Subject: Braidwood Station Units 1 & 2
Braidwood Construction Assessment Program
Monthly Meeting Minutes/Monthly Report
Docket No. 50-456 and 50-457

Meeting Summary
BCAP NRC/CECo/ERC Monthly Meeting
January 3, 1985 9:00 a.m.
Mazon EOF

BRAIDWOOD CONSTRUCTION ASSESSMENT PROGRAM

CSR-I-H-003-043-001

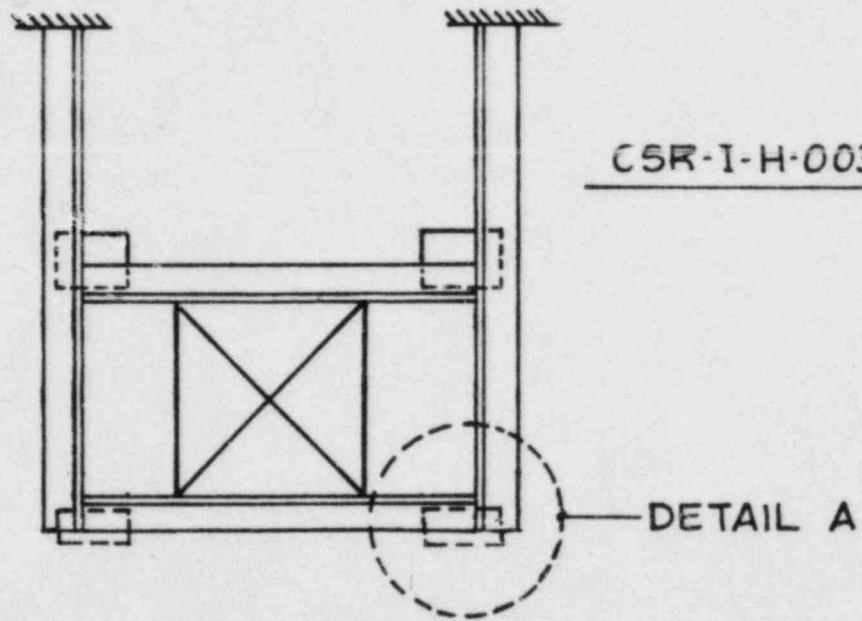
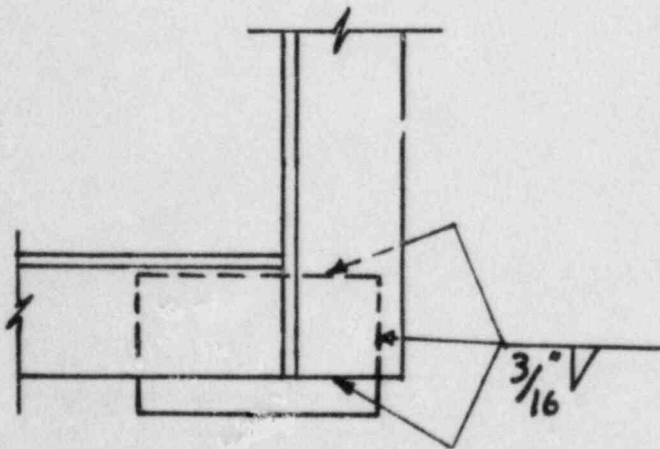
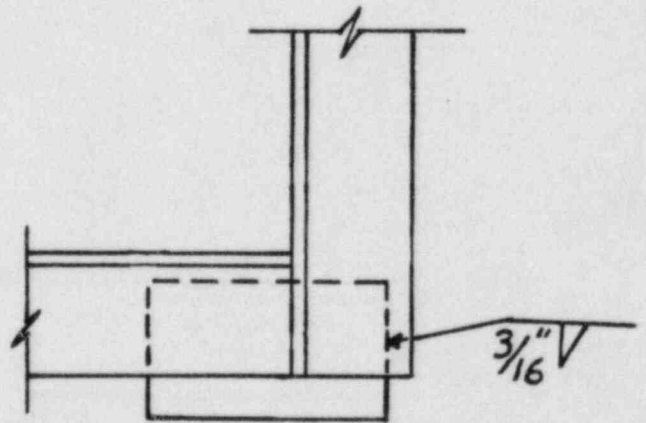
MISSING WELD ON
AN HVAC SUPPORT

DETAIL A
(AS-DESIGNED)

DETAIL A
(AS-BUILT)

CSR-I-S-01-049-001

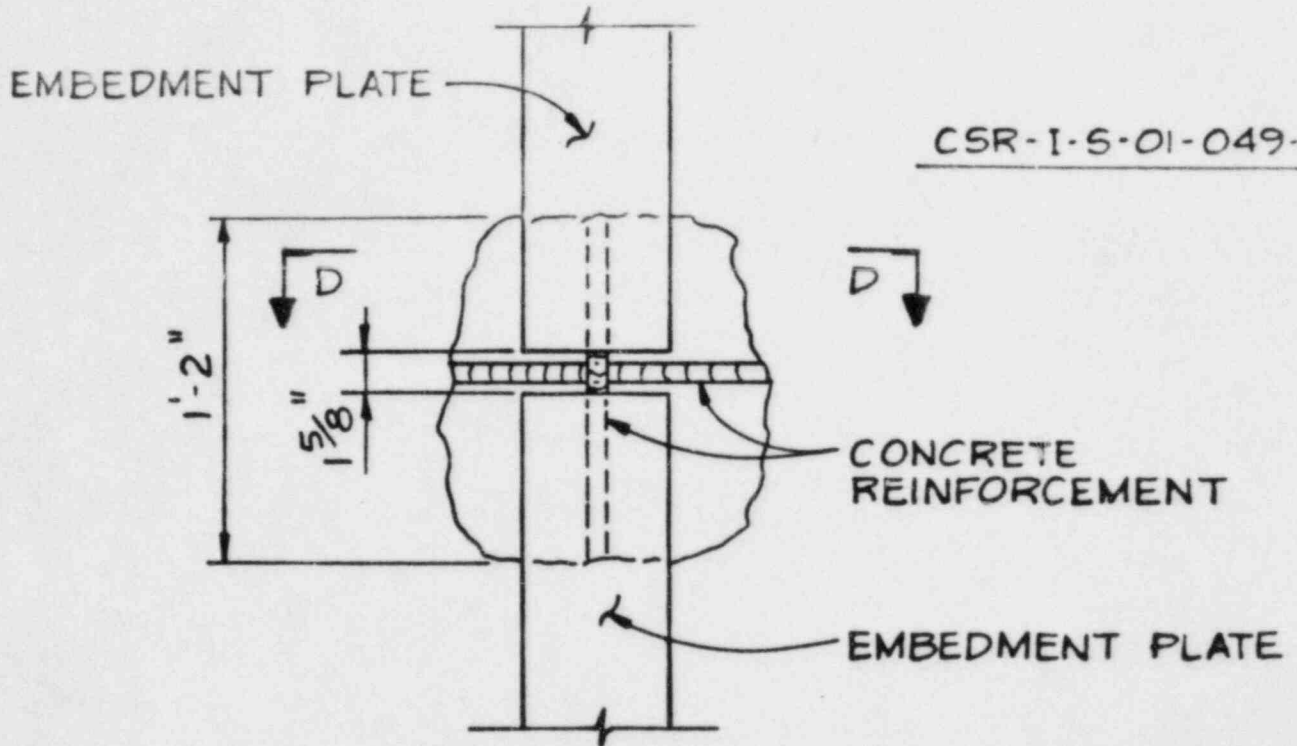
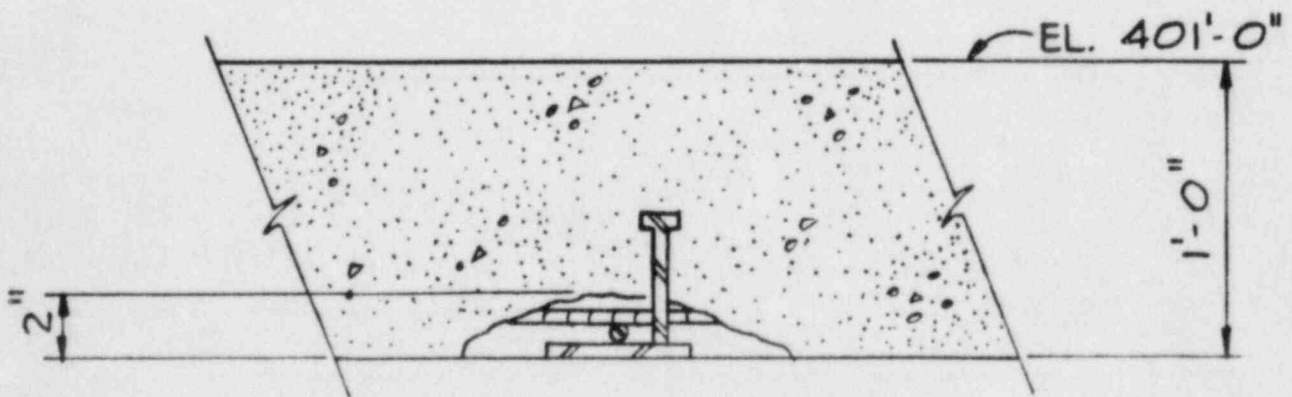
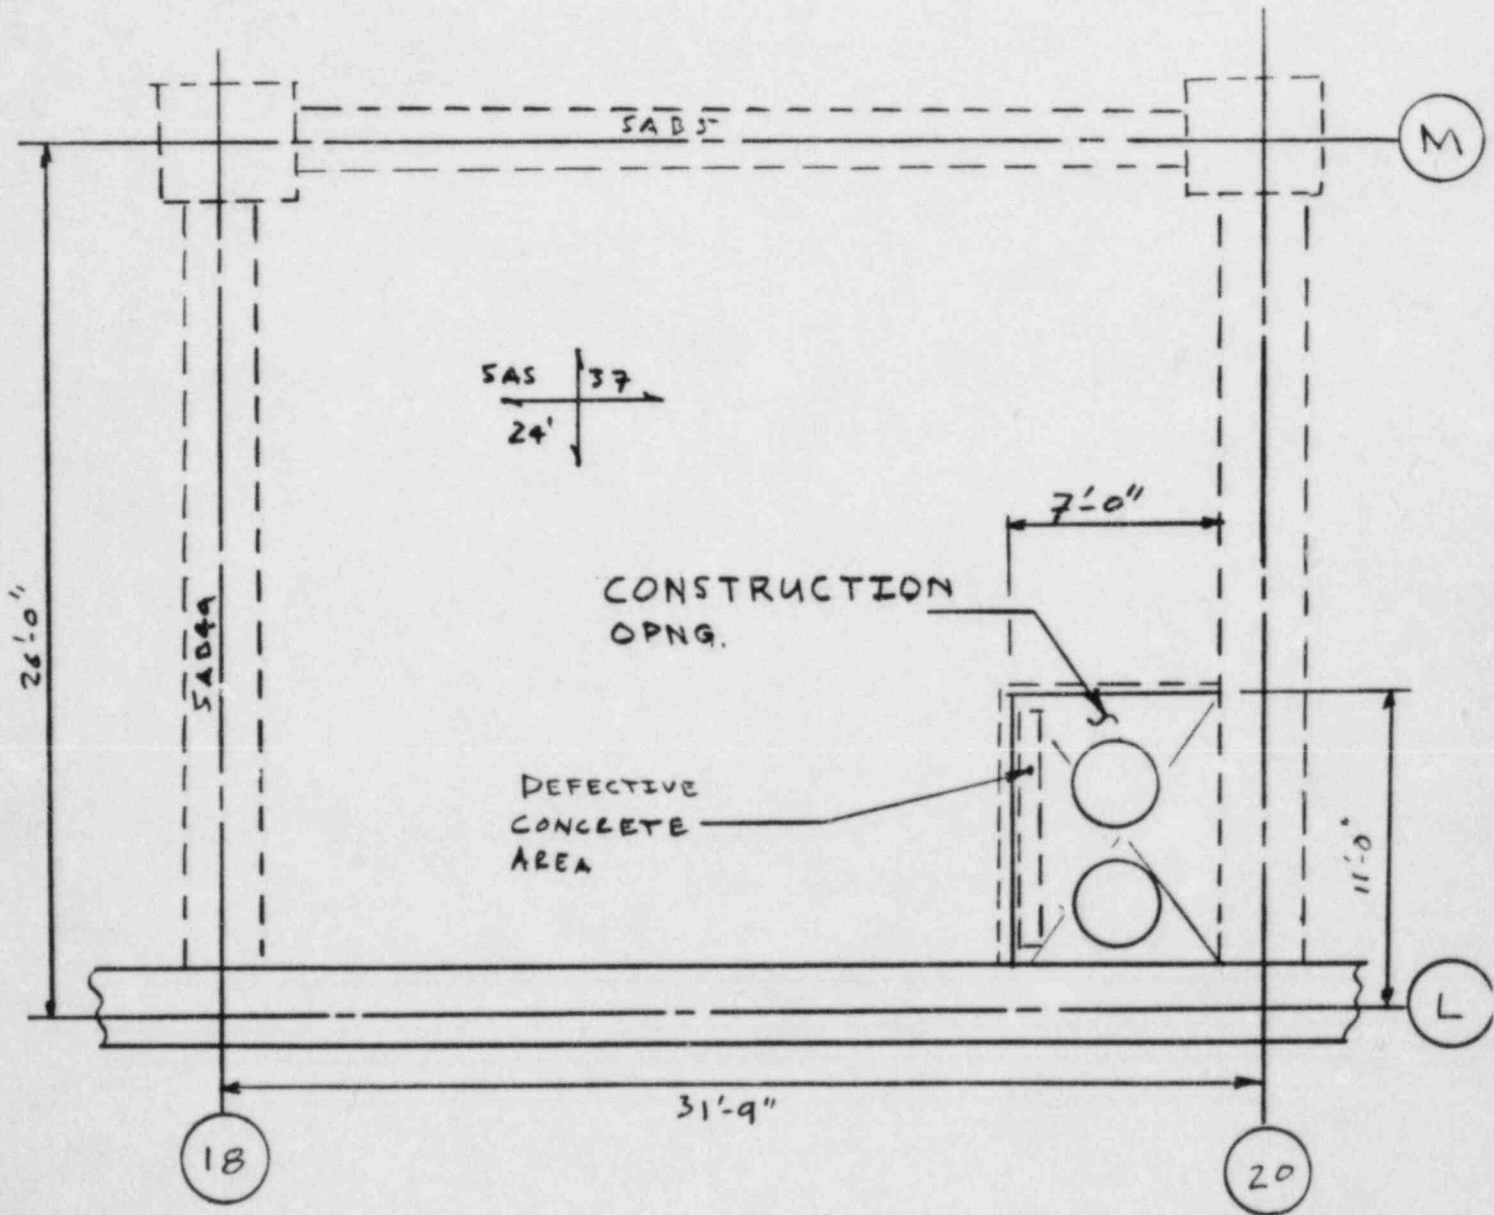
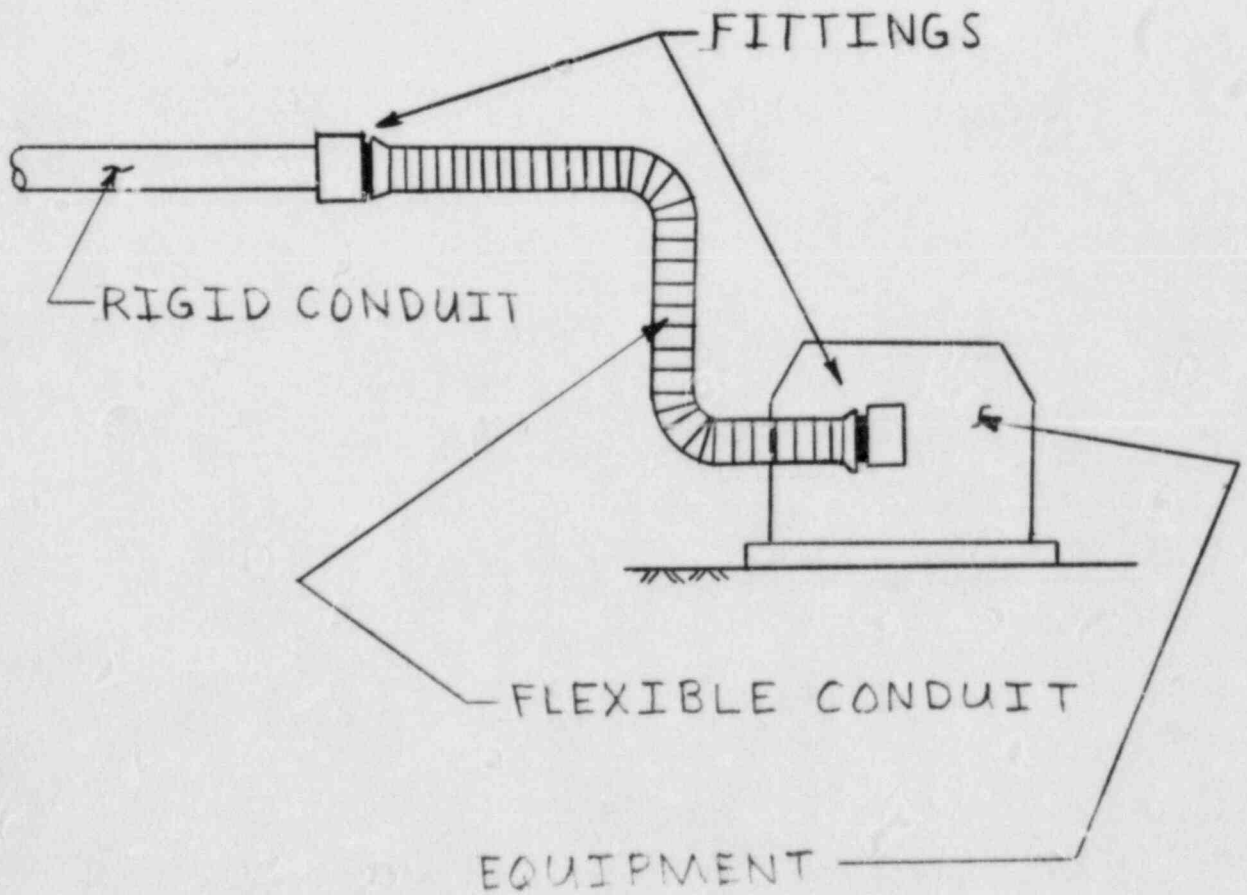
CONCRETE REINFORCEMENT EXPOSED DUE
TO SURFACE DEFECTS IN SLAB

OBSERVED DISCREPANCY

DEFECTIVE CONCRETE OBSERVATION :

SEGREGATION CODE LABELS

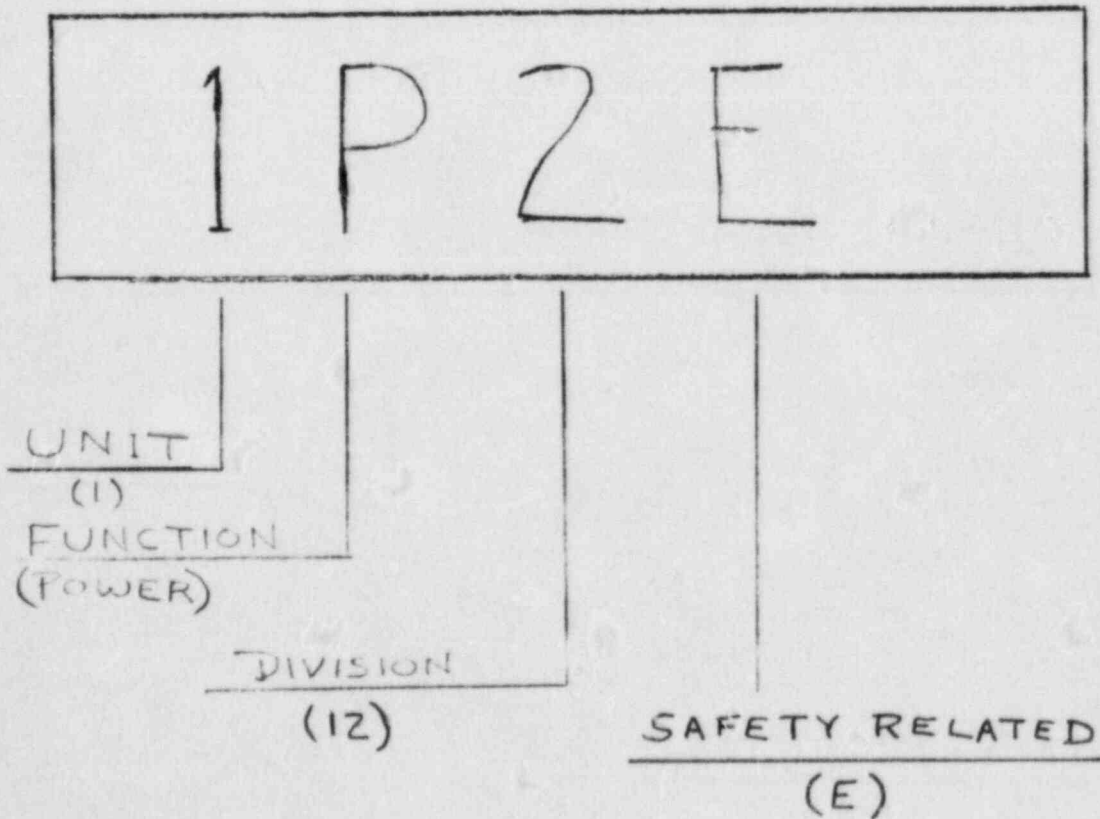
- A. CONDUIT MISSING SEGREGATION CODE LABEL AT EQUIPMENT END
- B. ONLY ONE HALF OF SEGREGATION CODE ON CONDUIT IC OF ICIE

DISCREPANCY # CSR-I-M-01-030-1

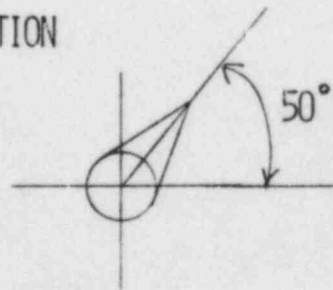
VALVE 1RC8060D STEM ORIENTATION

AS DESIGNED
AND QC ACCEPTED

AS REINSPECTED
BY BCAP

CSR-I-H-03-025-002

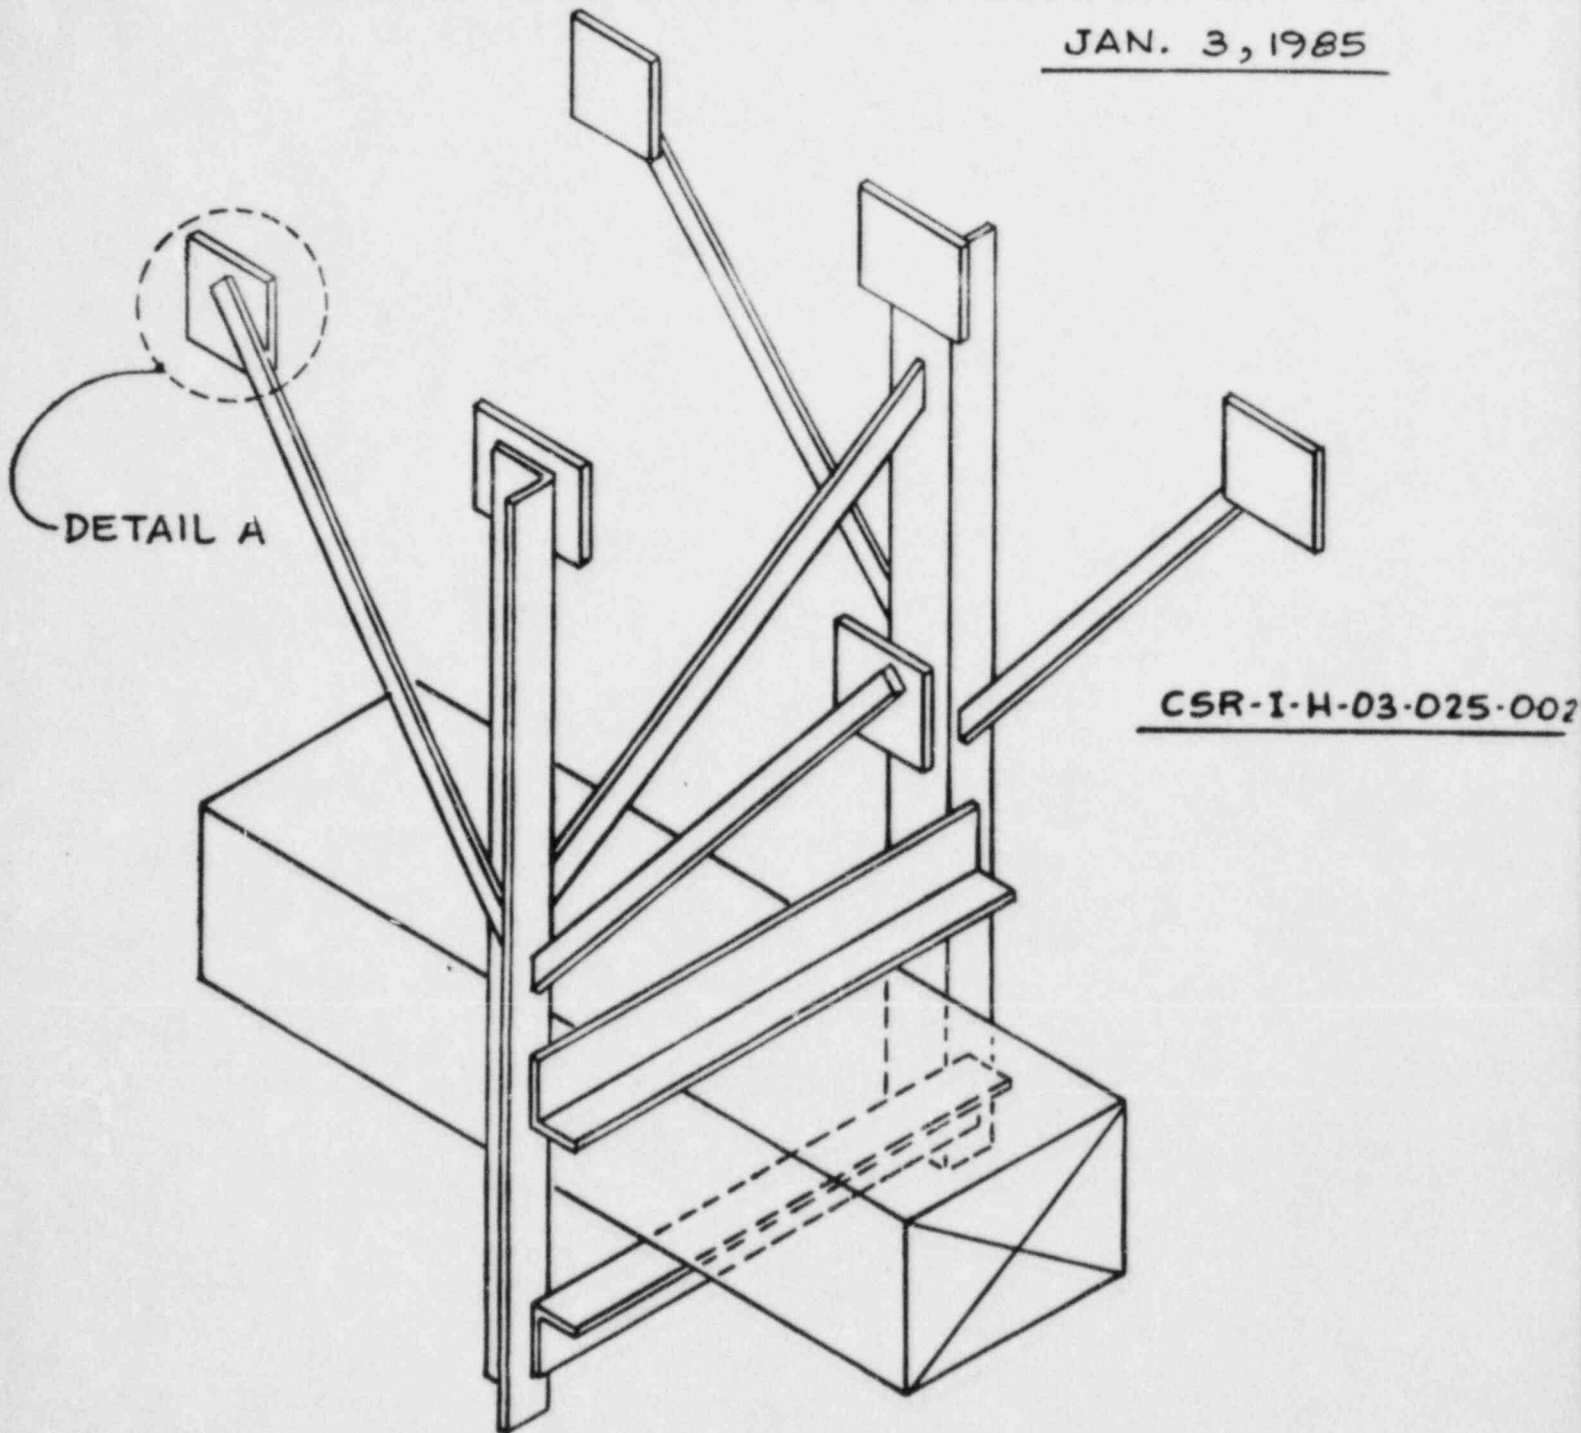
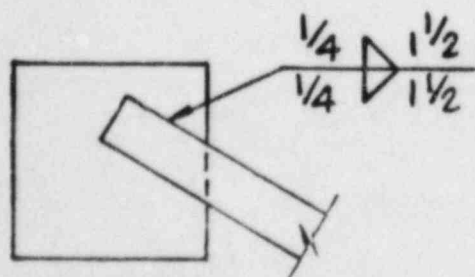
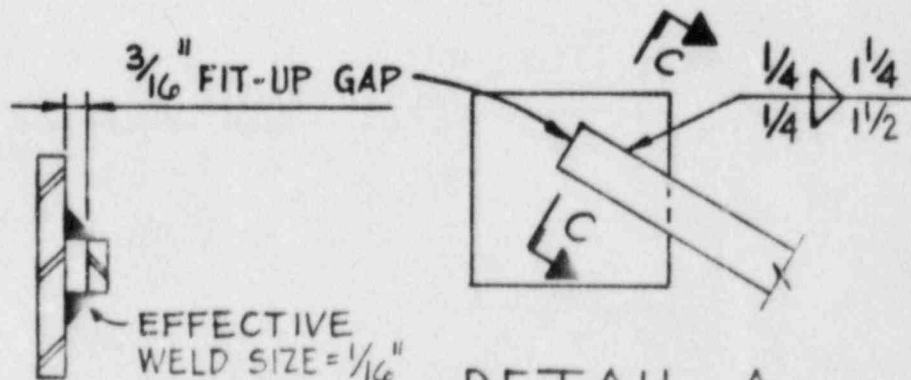
FIT-UP GAP AND UNDERLENGTH FILLET

WELD ON AN HVAC SUPPORT

DETAIL A
(AS-DESIGNED)

DETAIL A
(AS-BUILT)

FIT-UP GAP AND UNDERSIZE FILLET WELD ON AN HVAC SUPPORT

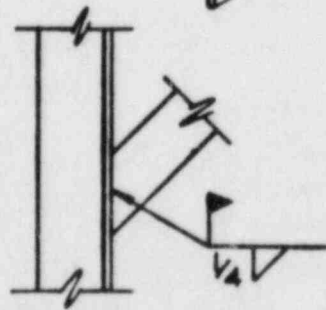
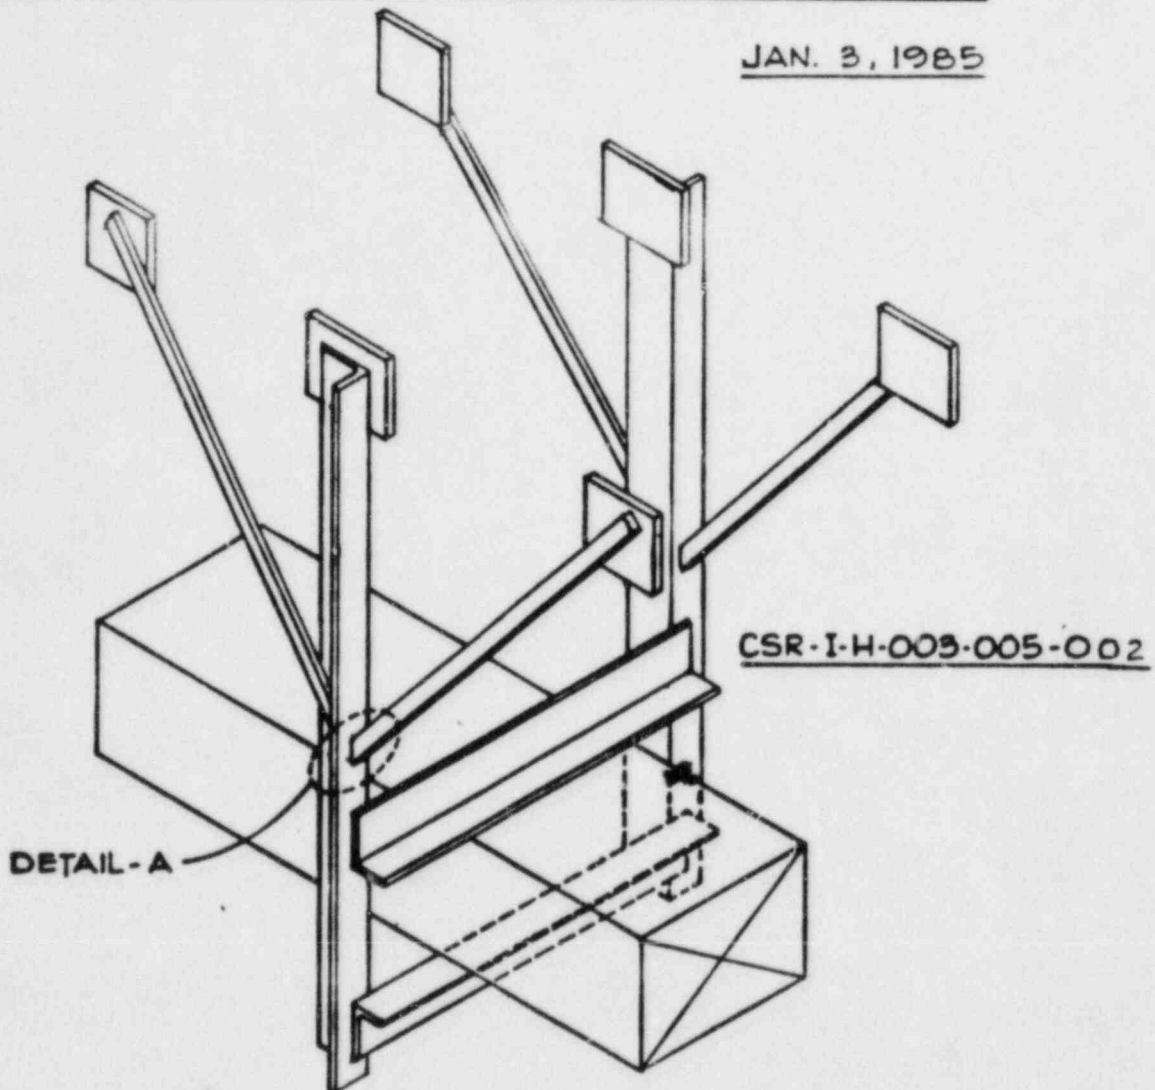
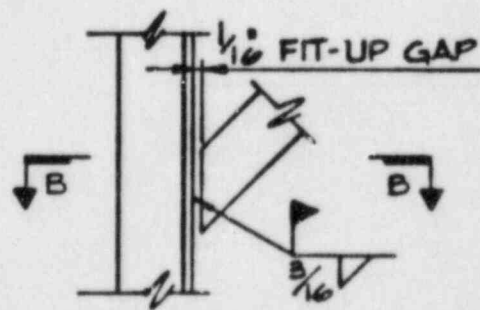
DETAIL - A (AS DESIGNED)

DETAIL - A (AS BUILT)
